# Access Compliance Report

## Public Rights-of-Way

### (Curb Ramps)

Intersection ID: 9172	Main Street: E_CRAIGHEAD_RD	Cross Street: N_TRYON_ST	Location:	NW
ADA ID: 968FF211DFBA	Ramp Type: Perp	Initial Pass/Fail: Fail	Overall Compliance: No	Severity Score: 8.75
Codes/Mitigation Info/Possible Solution		Field Measurements/Component Compliance

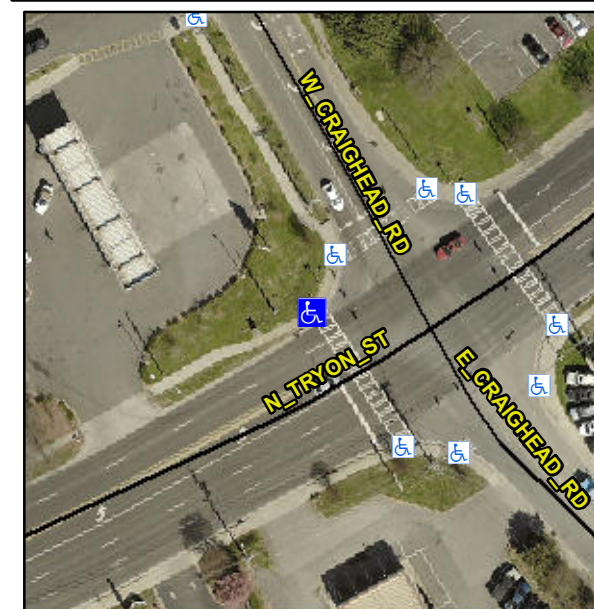
**Not Found, R304.5.1**

Compliance	Description	Data	Compliance	Description	Data
N/A	Ramp Length (in)	72.5	Yes	Ramp Slope (%)	5.3
No	Ramp Width (in)	40.5	Yes	Ramp XSlope (%)	0.4
N/A	Flare Type LT	N/A	N/A	Flare Type RT	N/A
N/A	Flare Slope LT (%)	N/A	N/A	Flare Slope RT (%)	N/A
N/A	Flare Traversable LT?	N/A	N/A	Flare Traversable RT?	N/A
N/A	Landing Length (in)	N/A	N/A	DWS Provided?	N/A
N/A	Landing Width (in)	N/A	N/A	DWS Contrast?	N/A
N/A	Landing Slope (%)	N/A	N/A	DWS Length (in)	N/A
N/A	Landing X Slope (%)	N/A	N/A	DWS Full Width?	N/A
N/A	Landing Curb? (Y/N)	N/A	N/A	DWS Offset (in)	N/A
N/A	Shared Landing?	N/A			
N/A	Gutter Ponding?	N/A	N/A	Gutter Slope (%)	N/A
N/A	Gutter Lip Ht (in)	N/A	N/A	Gutter X Slope (%)	N/A
N/A	Painted X Walk1?	Yes	N/A	Painted X Walk2?	N/A
	X Walk 1 Direction	To SE		X Walk 2 Direction	N/A
N/A	X Walk 1 Width (in)	90.5	N/A	X Walk 2 Width (in)	N/A
	X Walk 1 Slope (%)	1.9		X Walk 2 Slope (%)	N/A
	X Walk 1 X Slope (%)	0.3		X Walk 2 X Slope (%)	N/A

**Remove & Replace Entire Ramp.**
